OFFICE OF THE NEVADA ENVIRONMENTAL RESPONSE TRUST TRUSTEE

August 3, 2016

RE: Response to Comments – Seep Well Field Area Bioremediation Treatability Study Work Plan
Nevada Environmental Response Trust
Henderson, Nevada

FIELD TEST CONCEPTUAL LAYOUT

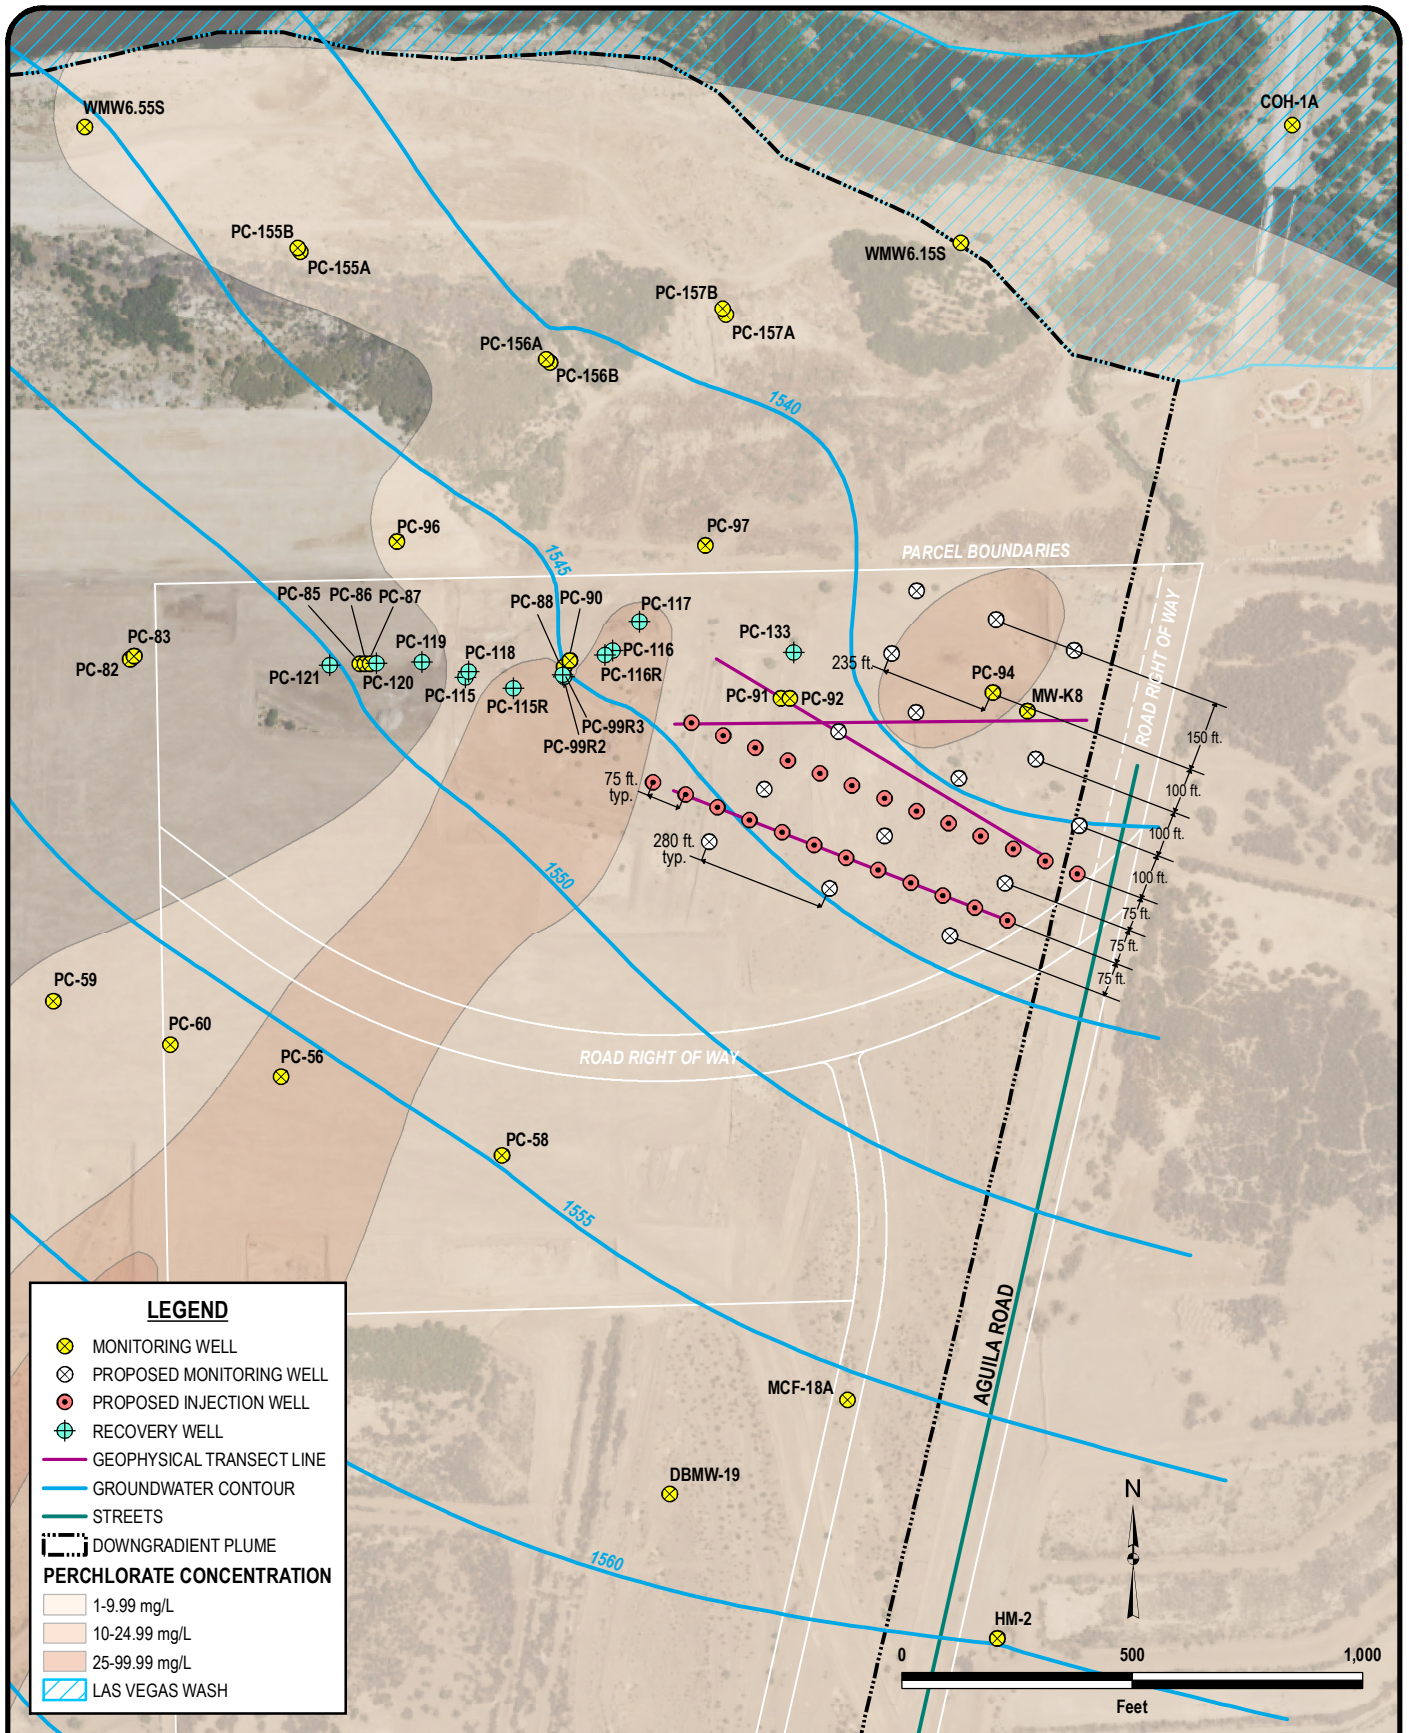
- 3) *Proposed monitoring wells in Figure 2 (Field Test Conceptual Layout) lack further downgradient sites and are narrow compared to the width of the injection wells. NDEP suggests that NERT adding additional monitoring wells in further and wider downgradient area of the injection wells. If the access is an issue for the downgradient area, NERT should consider utilizing existing wells and the surface water sampling site of LW5.5.*

To address the portion of the comment regarding the lack of monitoring wells located farther downgradient of the injection well transects, existing monitoring wells COH-1A (if accessible), MW-K8, PC-91, PC-92, PC-97, and PC-133 will be added to the wells to be sampled as part of the effectiveness monitoring program.

To address the portion of the comment regarding the monitoring well network required to address the width of the injection well transects, Figure 2 has been revised to show the location of the geophysical transects that will be evaluated during the Preliminary Field Activities phase. Per Section 3.4.1.2, "As many as ten borings could be converted to permanent monitoring wells, some or all of which may be installed as paired wells with separate screened intervals in both the alluvium and UMCf." These wells will be located along the lengths of the geophysical transects, with final locations being decided based on geophysical results. Therefore, there will be additional monitoring wells that will be periodically sampled and could be added to the effectiveness monitoring program that will help evaluate the effectiveness of the entire width of the injection well transects.

Section 5.1.1 and Figure 2 will be updated accordingly. The following statement will be added to Section 5.1.1:

"Effectiveness monitoring wells will include newly installed monitoring wells as well as existing monitoring wells COH-1A (if accessible), MW-K8, PC-91, PC-92, PC-94, PC-97, and/or PC-133.

Additionally, some or all of the monitoring wells installed during the preliminary field investigation may be sampled during the treatability study to assist in determining remedial effectiveness.”
